San Francisco Bay Conservation and Development Commission

SUBJECT: Ferry Building Alterations Project in the City and County of San Francisco; First Pre-Application Review

(For Design Review Board consideration April 10, 2023)

Figure 2: BCDC-Required Public Access

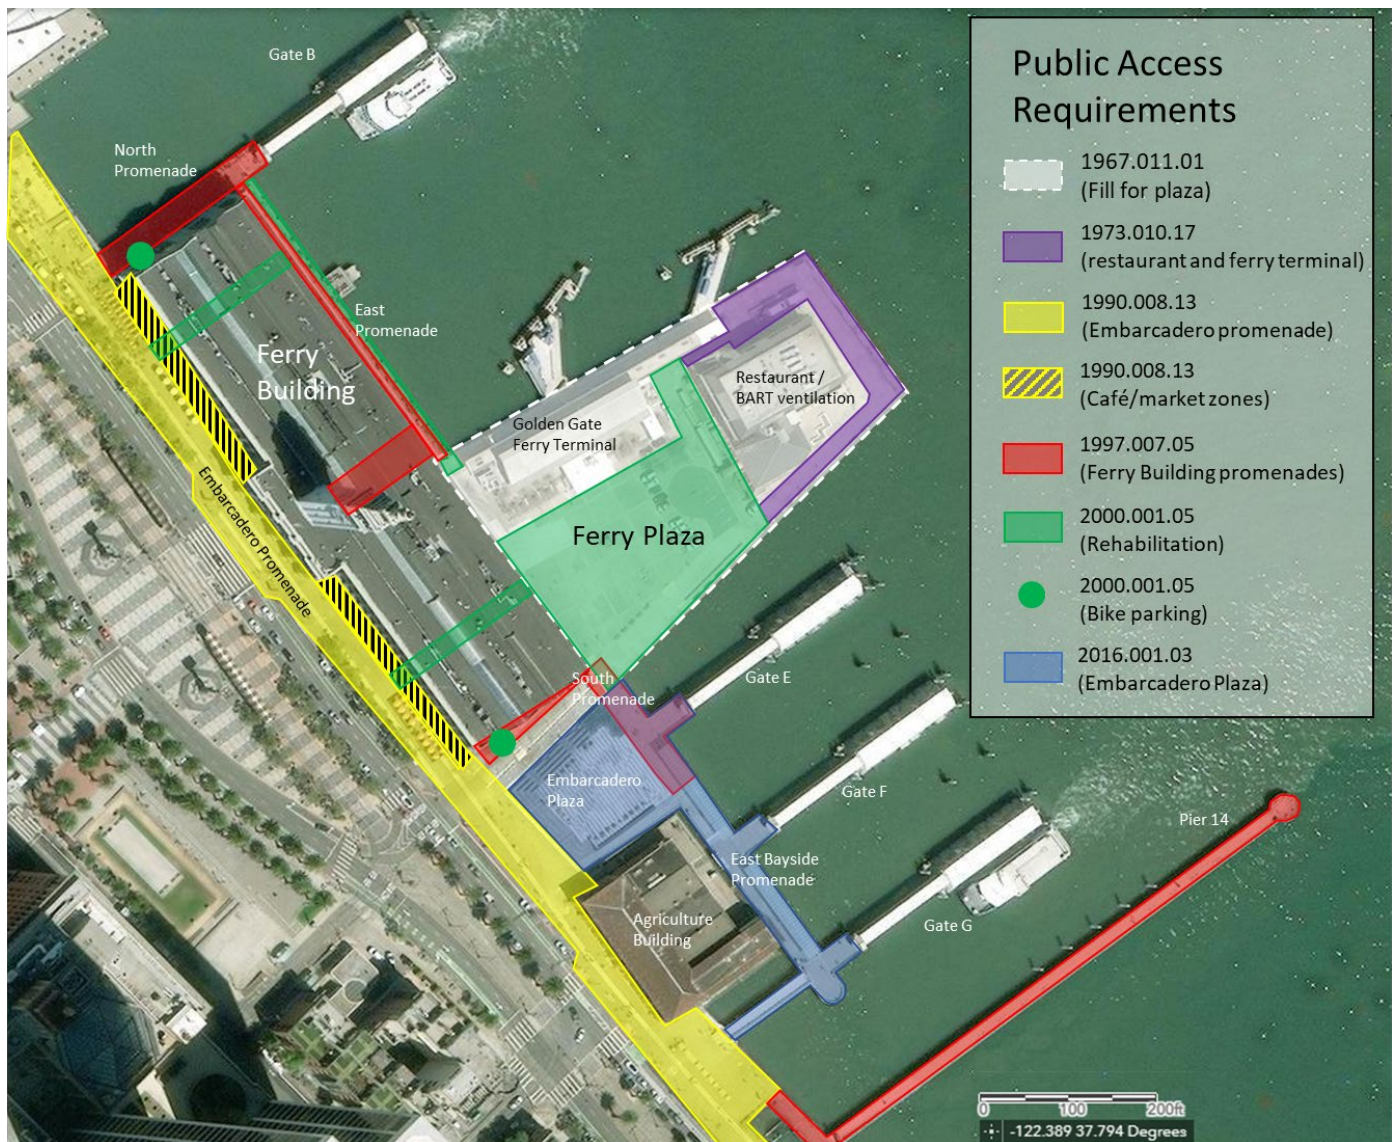
There are a number of existing BCDC permits associated with public access on and around the project site. Relevant public access requirements are summarized below and in Figure 2.

Figure 6: Bay Front Kitchens

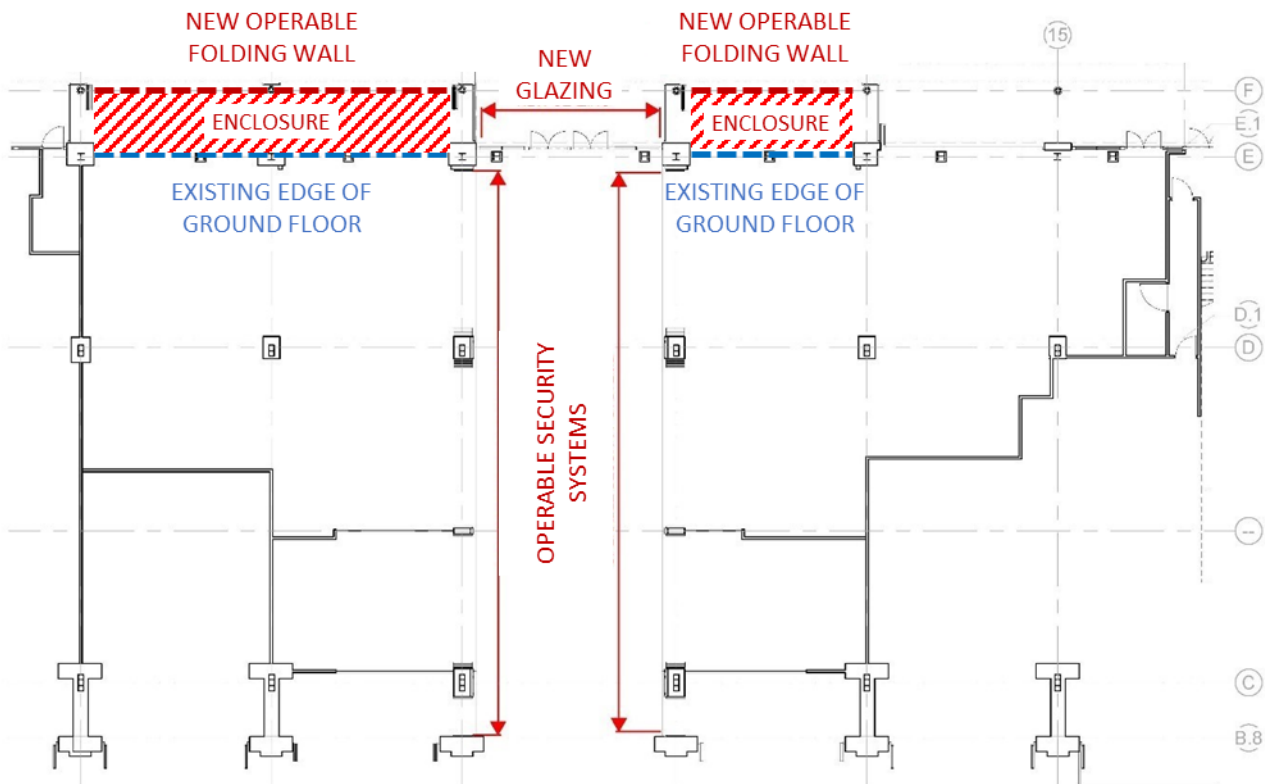
It should be noted that the areas proposed to be enclosed by the new folding wall system are public access areas required in BCDC Permit No. 2000.001.05. The Findings of the permit explain that the additional 12 feet of width added to the Eastern Promenade at the time was to ensure that the promenade would still have the same amount of public access area open to the sky after the extension of the second floor covered 9 feet of the previously available public access. Additionally, the 9 feet of covered public access was anticipated by the Findings to be available to the public as shelter during rainy weather but otherwise usable for outdoor dining.

3. Does the enclosure of the private dining areas on the East Promenade for the Bay Front Kitchens enhance activation and support inviting and usable public access areas? Is it necessary to enclose the private dining areas?
